Final Expert Statement

# **NPP SOUTH UKRAINE LIFETIME-EXTENSION ENVIRONMENTAL IMPACT ASSESSMENT**

*Final Expert Statement*

REPORT  
REP-0792

Figure 1.3:  
Fragment of the map of  
a geological structure of  
Ukrainian SSR and Mol-  
davian SSR (elements of  
the structure of geophys-  
ical fields)

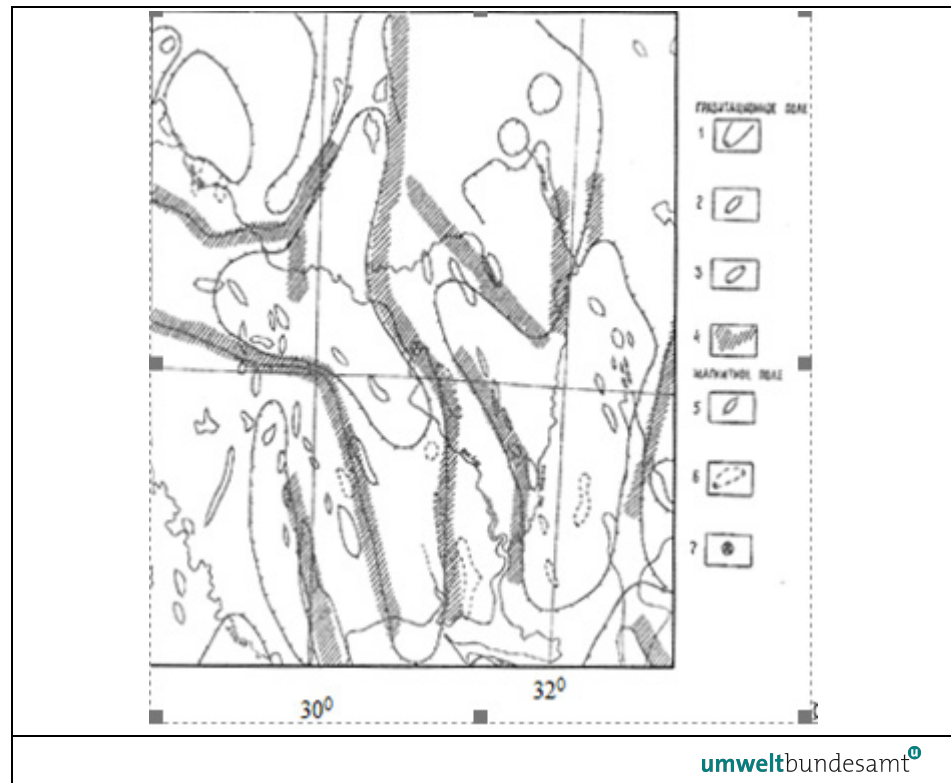
The Pervomaisk deep fault is manifested in the form of a system of closely adjacent faults of the earth's crust (Akmechetski, Voznesensk, Mykolaiv, etc.), concentrated in a zone up to 10 kilometers or more wide. In the area of the power complex, it has a northwest strike and a northeast dip of fault planes. According to preliminary data obtained in the course of seismic studies carried out by the Institute of Geophysics of the National Academy of Sciences of Ukraine and the Central Geophysical Expedition, displacements along the Moho surface are associated with the Pervomaisk fault zone. In the gravitational field, a sharp gravity step corresponds to it which separates the Golovanivsk maximum and the Kirovograd gravity minimum (Figure 1.3).

Ukrainian experts' answer confirmed that the Thalne fault and the Pervomaisk fault were investigated in detail.
